UNITED STATES PATENT AND TRADEMARK OFFICE

APPLICATION NO.	FILING DATE	FIRST NAMED INVENTOR	ATTORNEY DOCKET NO.	CONFIRMATION NO.
10/766,580	01/27/2004	Yutaka Yanuma	17405	3872

Office Action Summary

DETAILED ACTION

FIG. 4

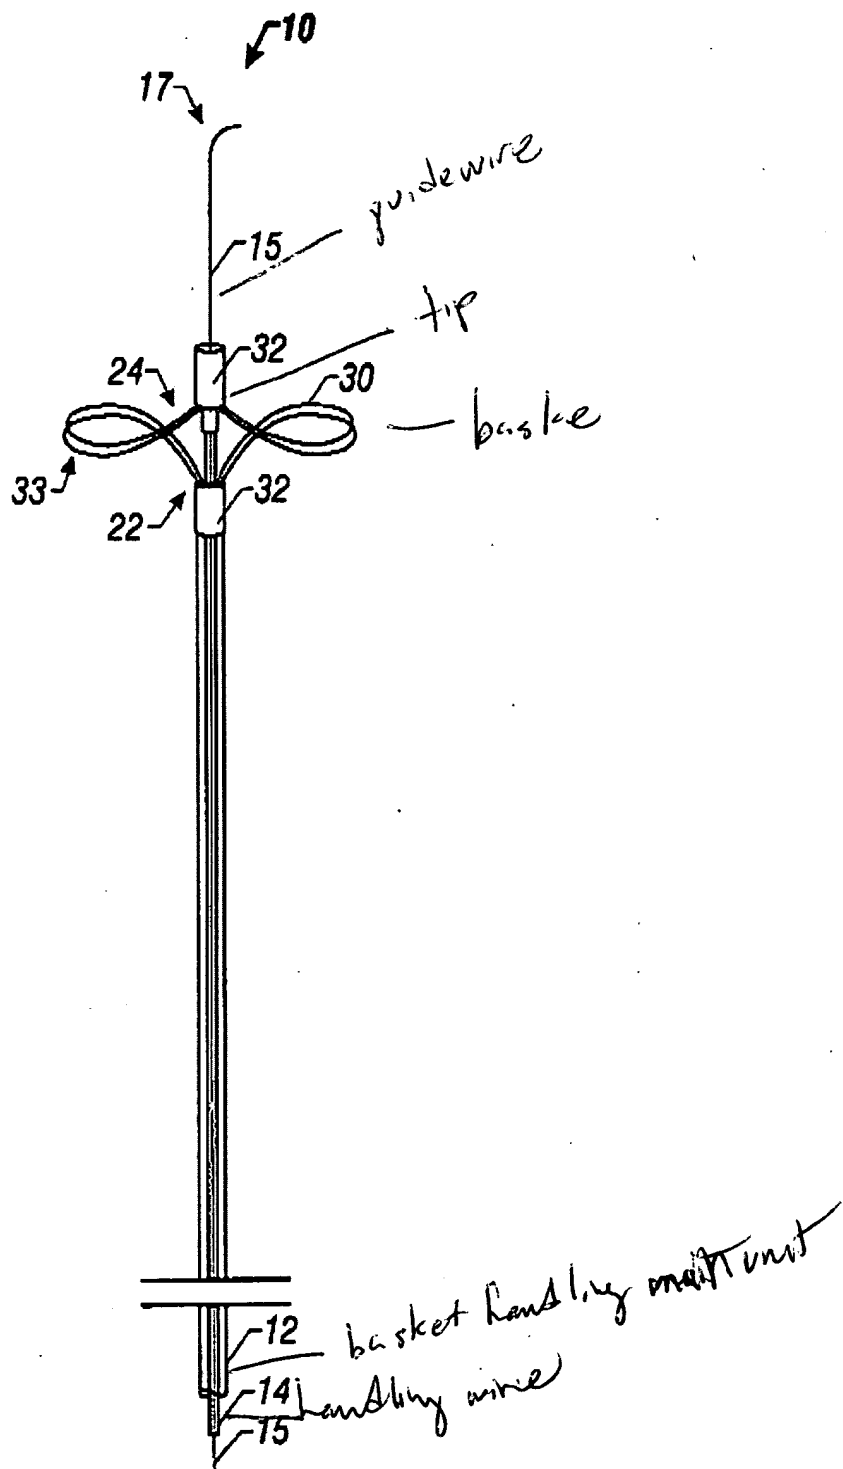
4. Basket forceps comprising: a slim sheath (col. 7, lines 20-24); a handling wire; a basket unit coupled to a distal end of the handling wire, the basket unit having a plurality of basket wire, each of the basket wires having front and rear ends, the front ends of the basket wires being bundled, the rear end of the basket wires being also bundled, the basket wire thus providing a basket; a tip member; a tubular basket-handling main unit; a guide wire insertion hold formed through the tip member and extending from a front surface to the tip member to an outer periphery of the tip member, a guide wire being inserted through the guide wire insertion hole. (The periphery of the tip member is the entire out side of the tip, including a front side, a back side and a side wall. The claim does not specify where the hole is on the periphery. Therefore the backside of the tip

taught by Konya et al. reads on the limitation.); wherein the sheath has an insertion lumen formed therein for inserting the handling wire and the guide wire.

Fig. 12

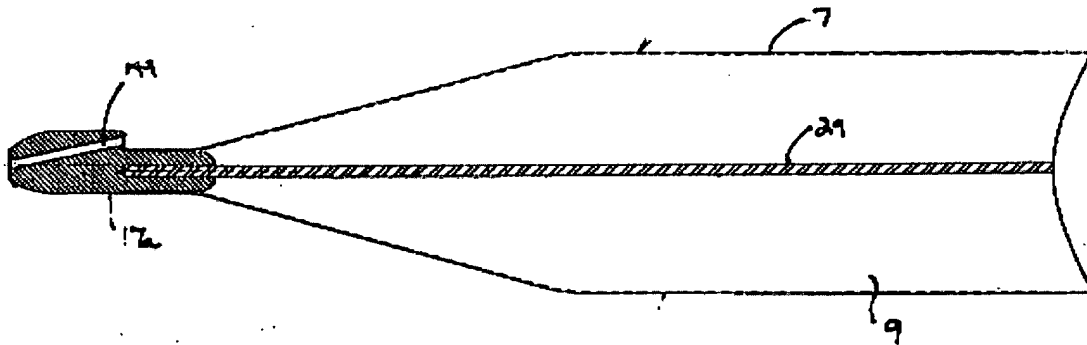
9. Konya et al. teaches the basket forceps according to claim 1. It should be noted that Konya et al. fails to teach wherein the tip member is provided with a wire bundling portion with bundles the basket wires, the tip member being also provided with the guide wire insertion hole which is not aligned with the wire bundling portion.

10. Wilcox et al. teach a device with a common tip. It would have been obvious to one having ordinary skill in the art at the time the invention was made to use the tip of Wilcox et al. as an alternate way of routing a guide wire.
